PLANNING APPLICATION

Owner Ms India Bourke
Project 48a South Hill Park
 London NW3 2SJ
Subject SIDE ELEVATION
 existing and proposed
Date 09 April 2021
Scale 1:100 @ A3
Job No. AD 229
Drawing No. A B

AD229-11

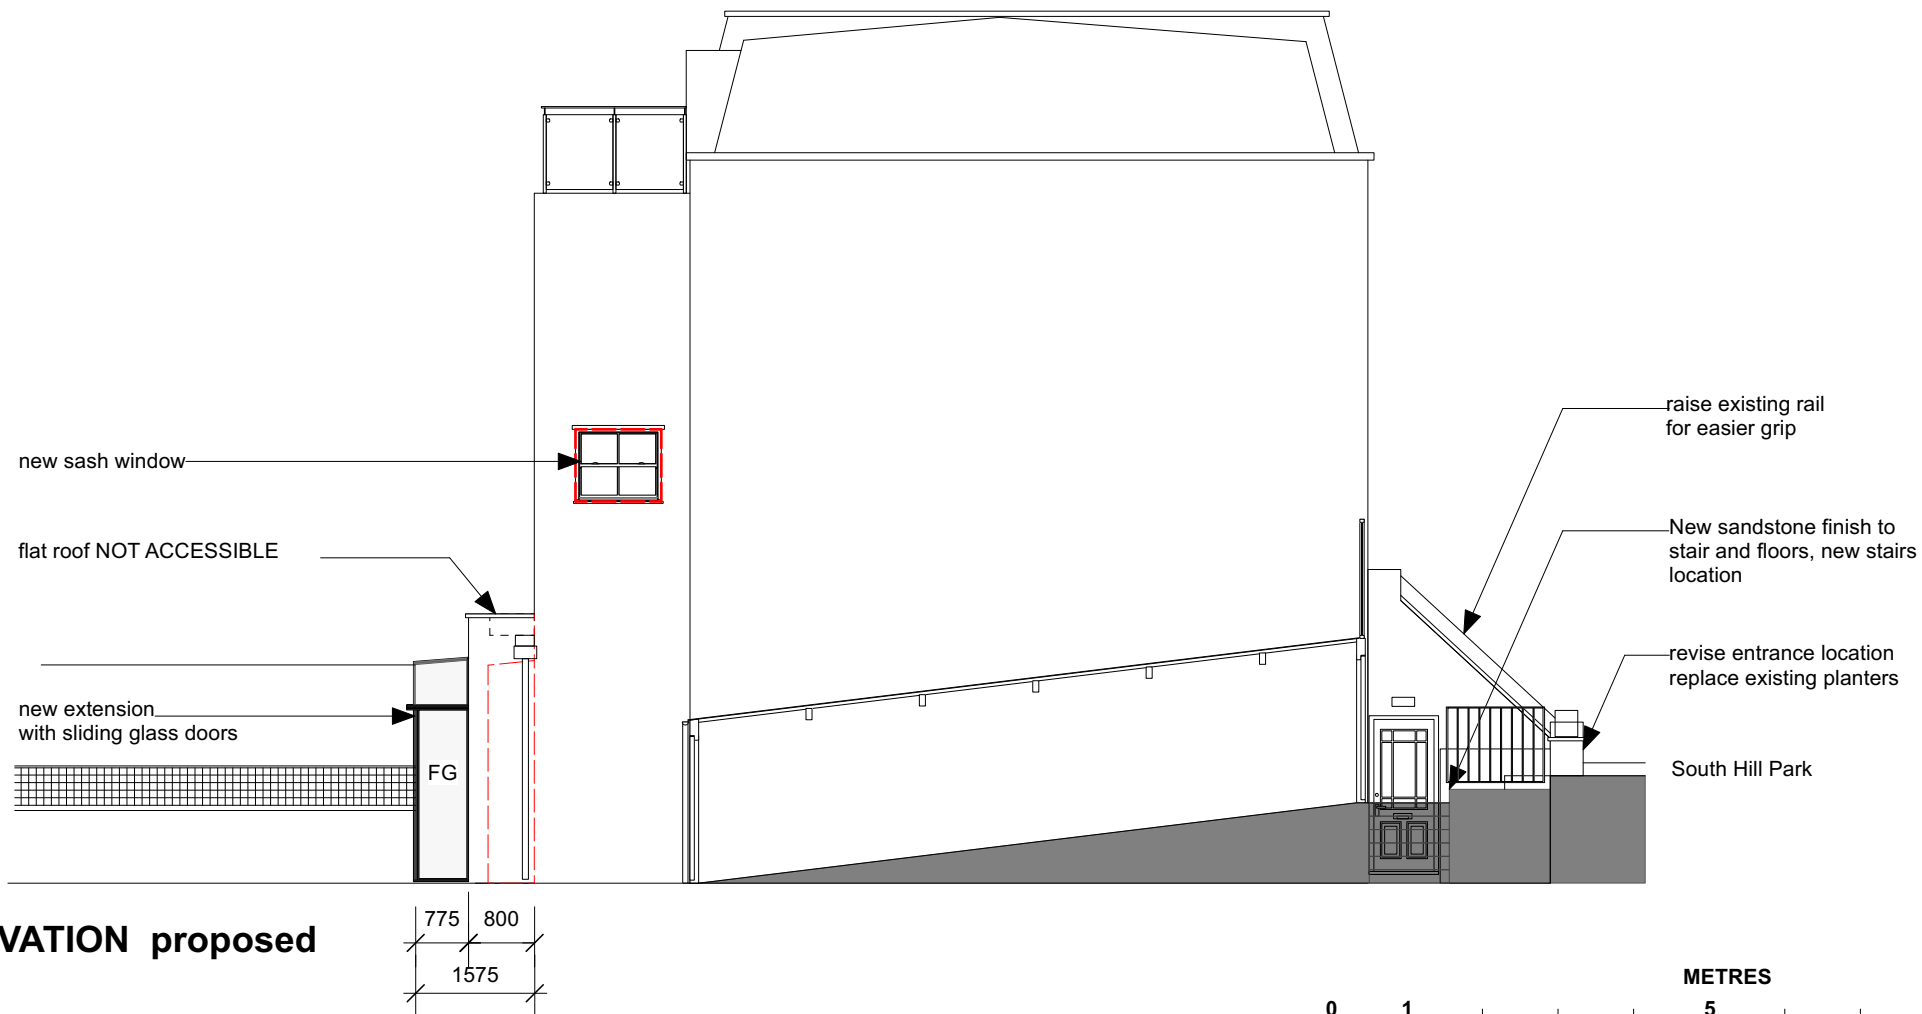
- A** 07.09.2021 Roof terrace accessible area reduced and extension's roof plan revised

Front lightwell - steps and bin location revised
- B** 27.09.2021 Roof terrace revised to non-accessible following planning requirements
